## **APPENDIX 4**

# **Appraisal of Design Audit for the New Barnet Victoria Quarter** for the Save New Barnet Group

September 2021

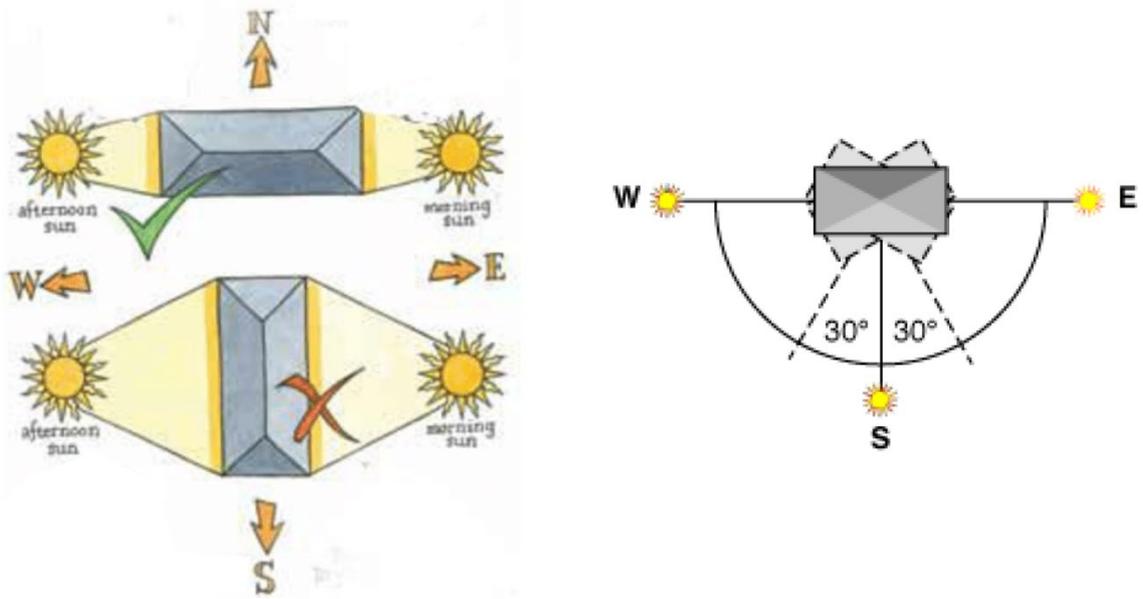
- 4.9. Item 4.14: “The reduced footprint subsequently reduces the long horizontal building form of the refused scheme and achieves a building footprint pattern which provides additional benefits in terms of orientation, improved separation, sunlight/daylight benefits and greater visual permeability”. In fact, the proposed orientation is exactly the wrong thing to do in terms of sunlight, overheating and passive energy design. Passivhaus principles recommend that main facades face north and south, as was the extant scheme for 371 units. As a result of this clumsy replanning, the current proposals are blighted by overheating from low level sun through large unshaded west facing windows. (Refer to diagrams on next page.)

Fig 2 (above): Two diagrams readily available on the internet showing the best orientation for passive solar design. The developers proposals have exactly the wrong orientation (as the red cross lower left) and consequently around 50% of the apartments require active cooling as a result of overheating. By contrast, apartments in the extant scheme of 371 units have a favourable orientation (top left with the green tick), making them inherently more sustainable
